Mosqueda Community Center - Exterior  
4760 East Butler, Fresno

Mosqueda Community Center (MCC)

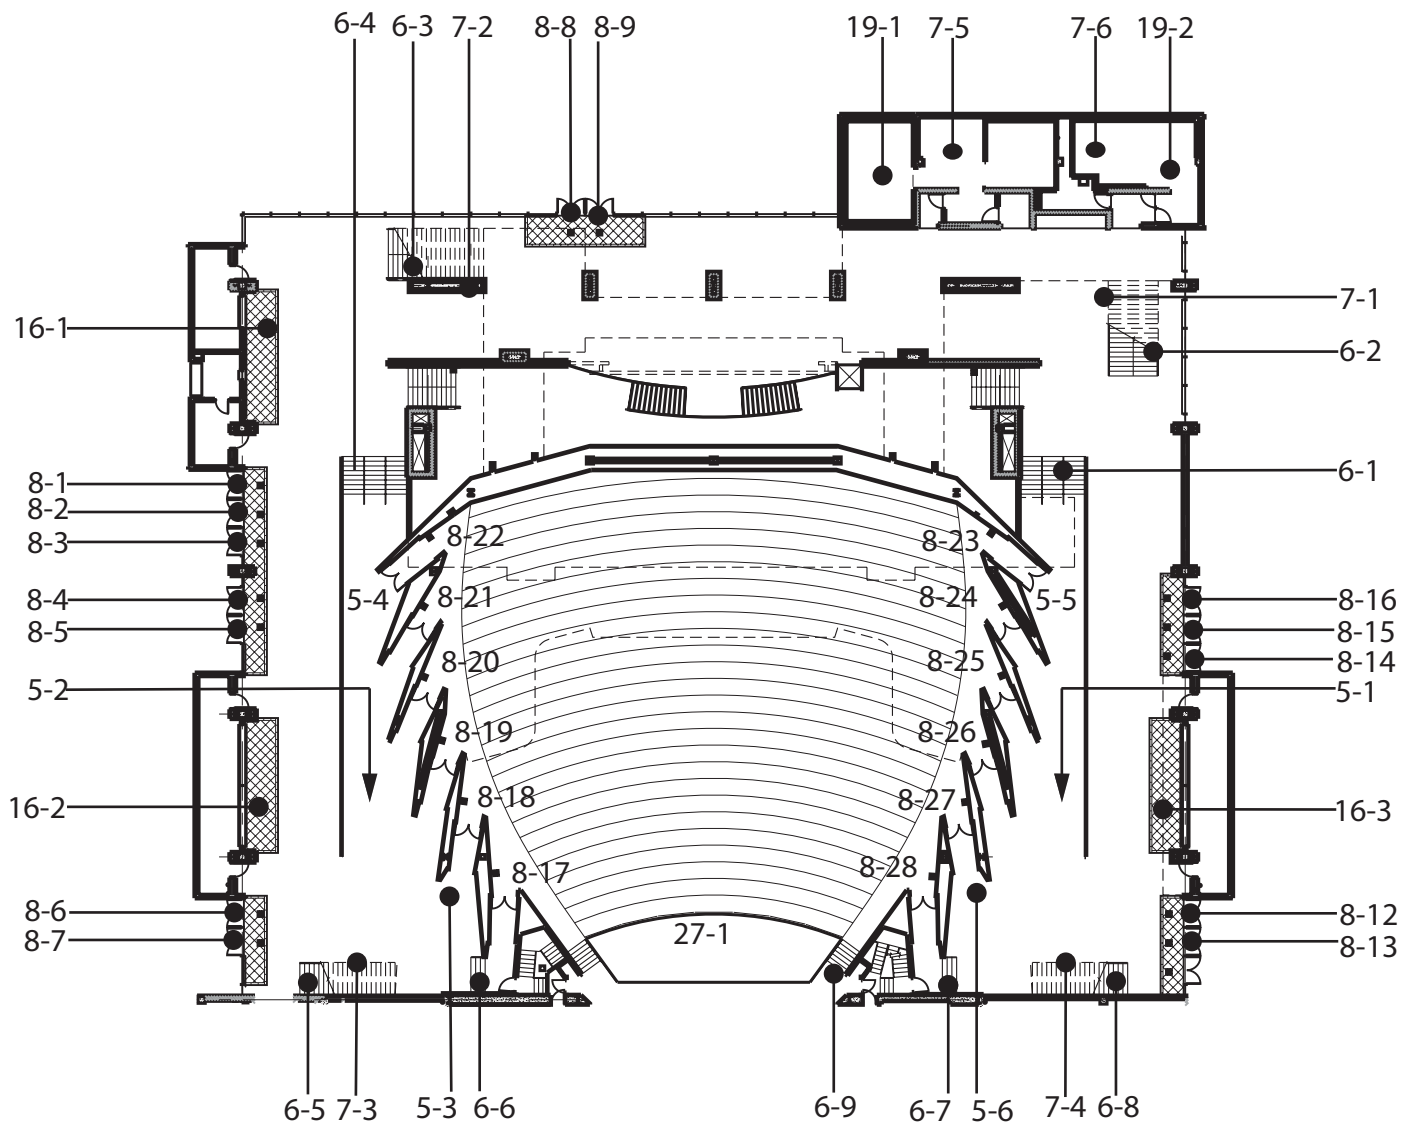
<b>Exterior</b>		
<b>4 - 1</b>	<b>Walk</b>	Priority: 1
<b>Regrade surface</b>		\$1,800
Notes: Cross slope recorded between 4.8% - 5.6% near drain (2% max.)		
State: 1133B.7.1.3		
Federal: 4.3.7		
<b>5 - 1</b>	<b>Ramp</b>	Priority: 1
<b>Regrade or replace ramp</b>		\$50,000
Notes: Running slope of ramp is 11.5% (8.33% max.) near the base of the ramp. Cross slope recorded at 5.0% (2% max.) along ramp run. Width of ramp is 43" (48" min.)		
State: 1133B.5.2, 1133B.5.3, 1133B.5.3.1		
Federal: 4.8.2, 4.8.3, 4.8.6		
<b>Install warning curb</b>		\$200
Notes: Drop off is 7-1/2". Warning curb is not provided.		
State: 1133B.5.4.9, 1133B.5.6.1, 1133B.5.6.2		
Federal: 4.1.7		
<b>6 - 1</b>	<b>Stairway</b>	Priority: 1
<b>Install or modify handrails</b>		\$2,000
Notes: There are no handrail extensions at the bottom of the stair run. Height of handrail is 30" (34" - 38" req.)		
State: 1133B.4.2.1, 1133B.4.2.2		
Federal: 4.9.4 #2, 4.9.4 #5

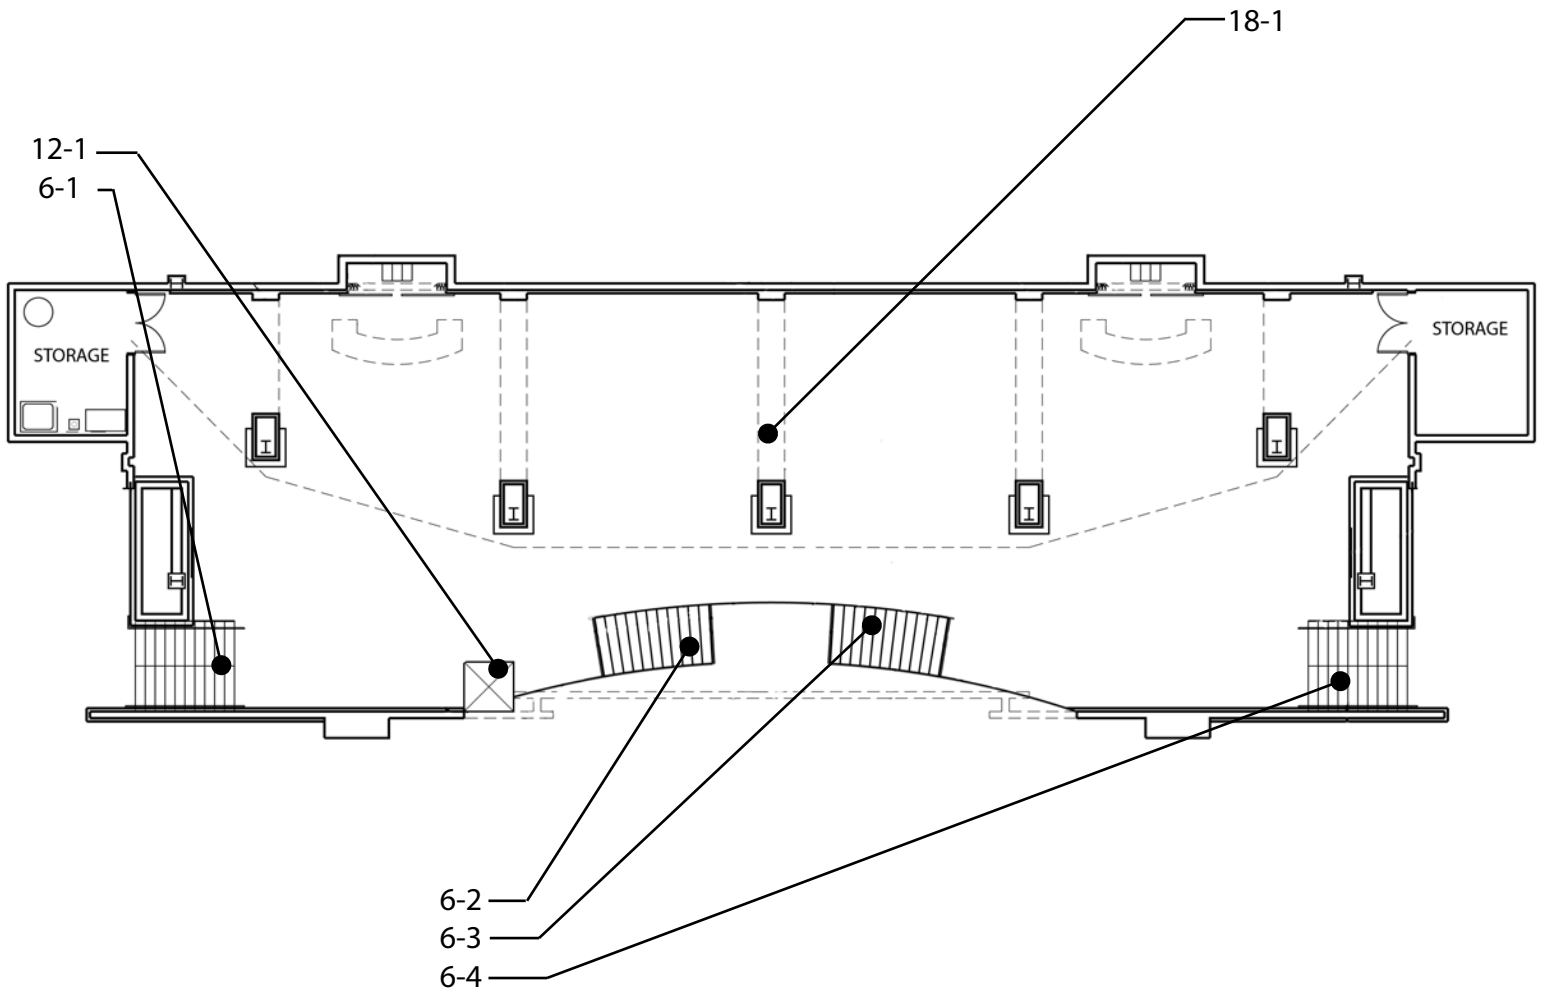
<b>Floor Lobby</b>		
<b>16 - 3</b>	<b>Transaction Counter</b>	Priority:2
	<b>Provide an accessible counter</b>	\$4,000
Notes: Counter height is 44-1/4" (34" max) above the finished floor.		
State: 1122B.5		
Federal: 4.32.4		
<b>19 - 1</b>	<b>Multiple User Restroom</b>	Priority:2
	<b>Modify lavatory/counter clearances</b>	\$3,500
Notes: Clear space beneath the lavatory sink is 28-1/2" (29" min.) Space under the bowl is 26" (27" min.)		
State: 1115B.4.3 #2		
Federal: 4.19.2		
	<b>Modify stall partitions and doors</b>	\$500
Notes: Clear space and stall width are 59" (60" min.)		
State: 1115B.3.1 #4.1		
Federal: 4.17.3		
<b>19 - 2</b>	<b>Multiple User Restroom</b>	Priority:2
	<b>Modify lavatory/counter clearances</b>	\$3,500
Notes: Clear space between the lavatory sink is 28" (29" min.) Space under the bowl is 26" (27" min.)		
State: 1115B.4.3 #2		
Federal: 4.19.2		
	<b>Replace or reposition dispensers or mirrors</b>	\$200

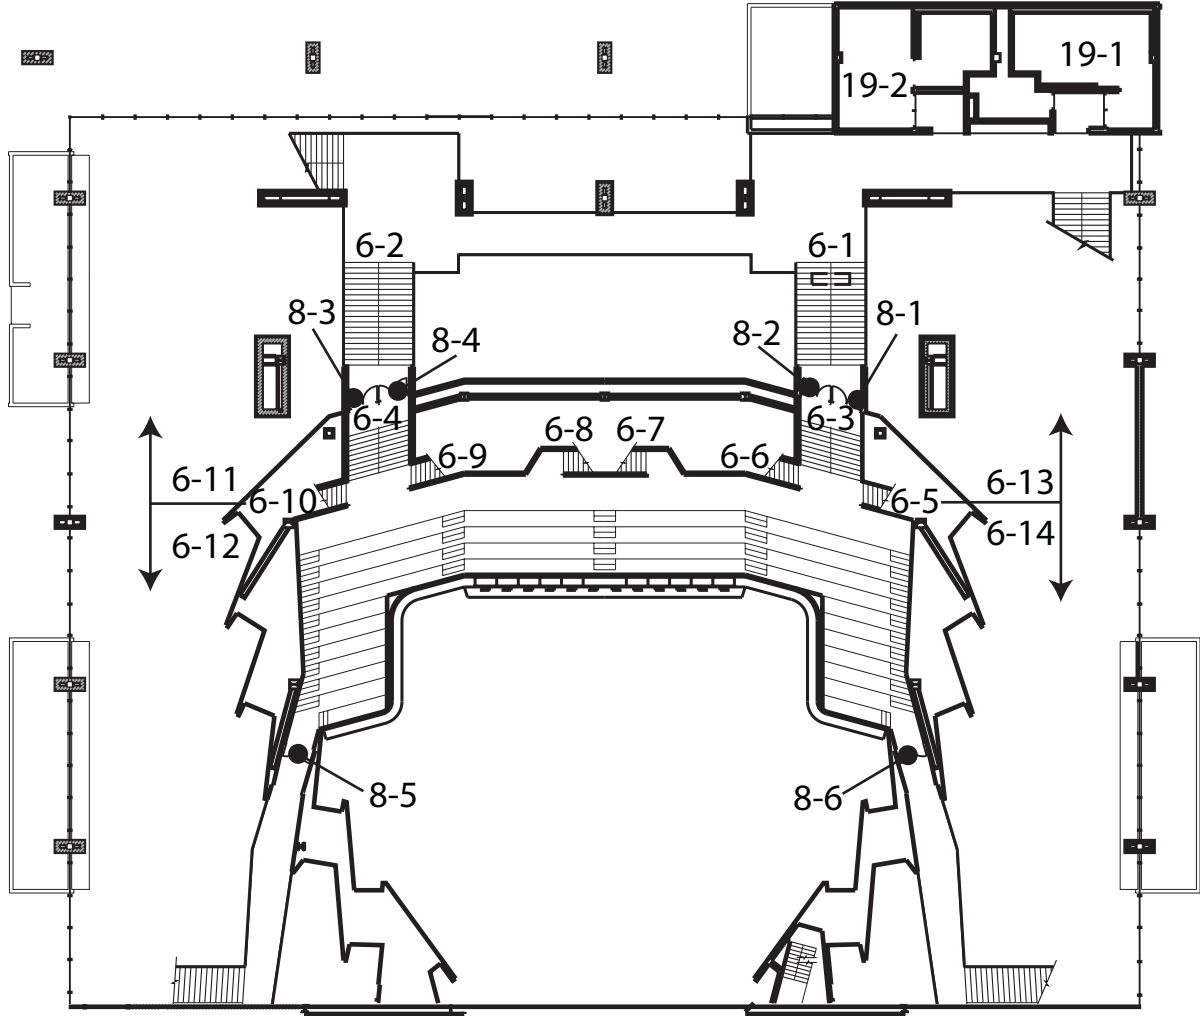
<b>Floor LowerLo</b>		
<b>6 - 1</b>	<b>Stairway</b>	Priority:2
<b>Install or modify handrails</b>		\$2,000
Notes: Handrails are interrupted on the wall side of stair run. No extensions provided on top or bottom of stair run. Handrail diameter is 1-1/2" x 9-1/4" (1-1/4" to 1-1/2" req.) Handrails are 1-3/4" from wall (1-1/2" req.)		
State: 1133B.4.1.1, 1133B.4.2.2, 1133B.4.2.5, 1133B.4.2.6		
Federal: 4.26.2, 4.9.4, 4.9.4 #2, 4.9.4 #3		
<b>6 - 2</b>	<b>Stairway</b>	Priority:2
<b>Install or modify handrails</b>		\$2,000
Notes: On wall side of stair run, bottom extension is 18" (12" + tread width min.) Top surface of handrail is mounted at 32" on wall side (34" to 38" req.)		
State: 1133B.4.2.1, 1133B.4.2.2		
Federal: 4.9.4 #2, 4.9.4 #5		
<b>6 - 3</b>	<b>Stairway</b>	Priority:2
<b>Install or modify handrails</b>		\$2,000
Notes: On wall side of stair run, bottom extension is 18" (12" + tread width min.) Top surface of handrail is mounted at 32" on wall side (34" to 38" req.)

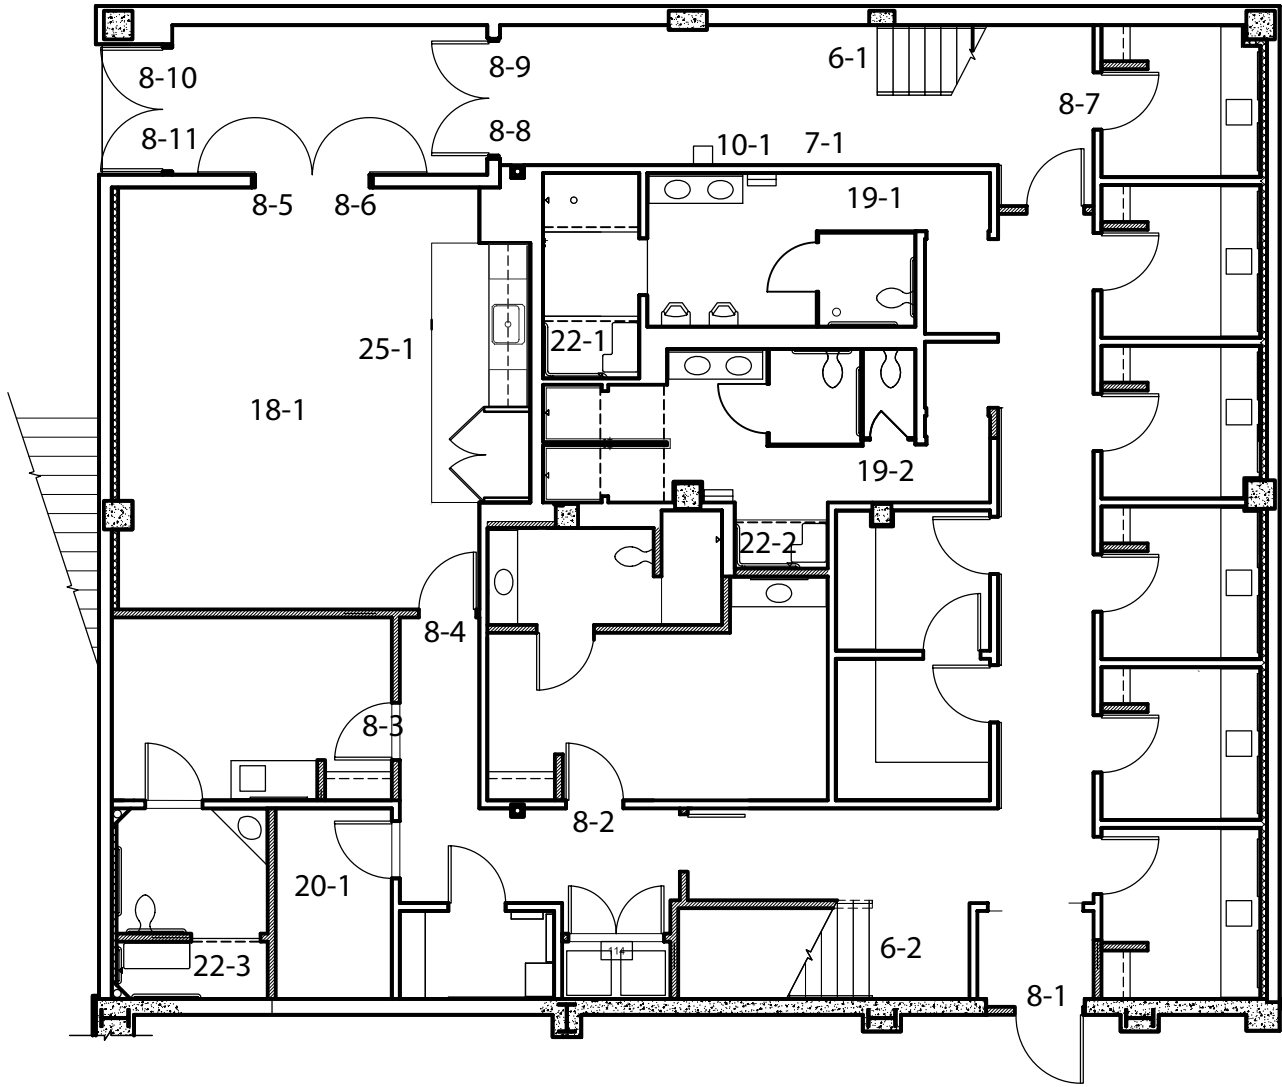
<b>Mezzanine</b>	
<b>6 - 13 Stairway</b>	Priority:2
<b>Install or modify handrails</b>	\$2,000
Notes: Handrail along wall does not have top extensions.	
State: 1133B.4.1.1, 1133B.4.2.2	
Federal: 4.9.4, 4.9.4 #2	
<b>Replace stairs</b>	\$0
Notes: Risers are 8" (7" max.) Width of stair narrows to 33" (44" min.)	
State: 1007.3, 1009.1, 1009.3	
Federal: -	
<b>6 - 14 Stairway</b>	Priority:2
<b>Replace stairs</b>	\$0
Notes: Risers are 8" (7" max.)	
State: 1133B.4.5.3	
Federal: 4.9.2	
<b>Install or modify handrails</b>	\$2,000
Notes: Handrail along wall does not have top extensions.	
State: 1133B.4.1.1, 1133B.4.2.2	
Federal: 4.9.4, 4.9.4 #2	
<b>8 - 1 Door/Gate</b>	Priority:2
<b>Adjust door closer</b>	\$100
Notes: Operating effort is 9 lbs. (5lbs. max).	
State: 1133B.2.5	
Federal: 4.13.11	
<b>8 - 2 Door/Gate</b>	Priority:2
<b>Adjust door closer</b>	\$100
Notes: Operating effort is 9 lbs. (5lbs. max).	
State: 1133B.2.5	
Federal: 4.13.11

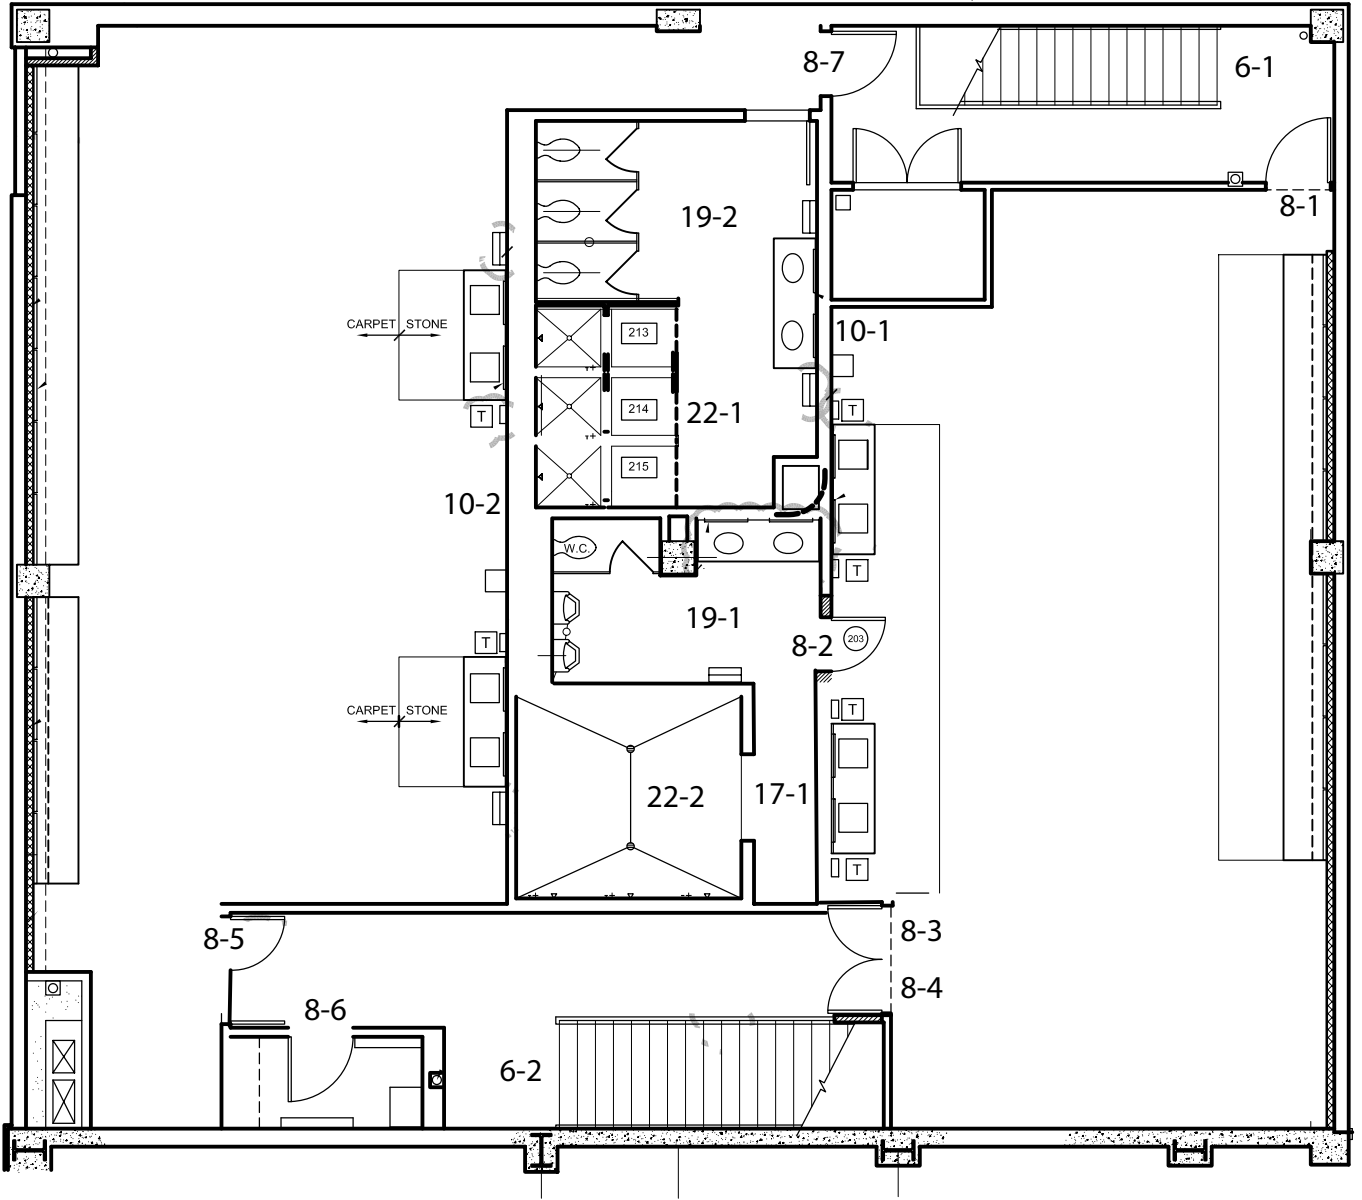
<b>Floor 1</b>	
<b>20 - 1 Single User Restroom</b>	Priority:2
<b>Install sign</b>	\$250
Notes: Appropriate 12" symbol not provided for signage. Braille not provided. Accessible facility not identified with Int'l Symbol of Accessibility.	
State: 1115B.6, 1117B.5.1 #1, 1117B.5.5 #3, 1117B.5.8.1.2	
Federal: 4.30.4	
<b>Modify lavatory/counter clearances</b>	\$3,500
Notes: 12" between wall and center of sink (18" min.). Clear space beneath sink is 28" (29" min.). Space under the bowl is 25" (27" min.).	
State: 1115B.4.3 #1, 1115B.4.3 #2	
Federal: 4.19.2	
<b>Increase or provide maneuvering or clear floor area</b>	\$2,500
Notes: Clear space in front of toilet is 37" (48" min.).	
State: 1115B.3.1 #4.1	
Federal: 4.17.3	
<b>Replace or modify grab bars</b>	\$200
Notes: Bars are centered 33-1/2" above the floor (must be 33").	
State: 1115B.4.1 #3	
Federal: 4.17.6	
<b>22 - 1 Bathing Facility</b>	Priority:2
<b>Provide an accessible shower</b>	\$750
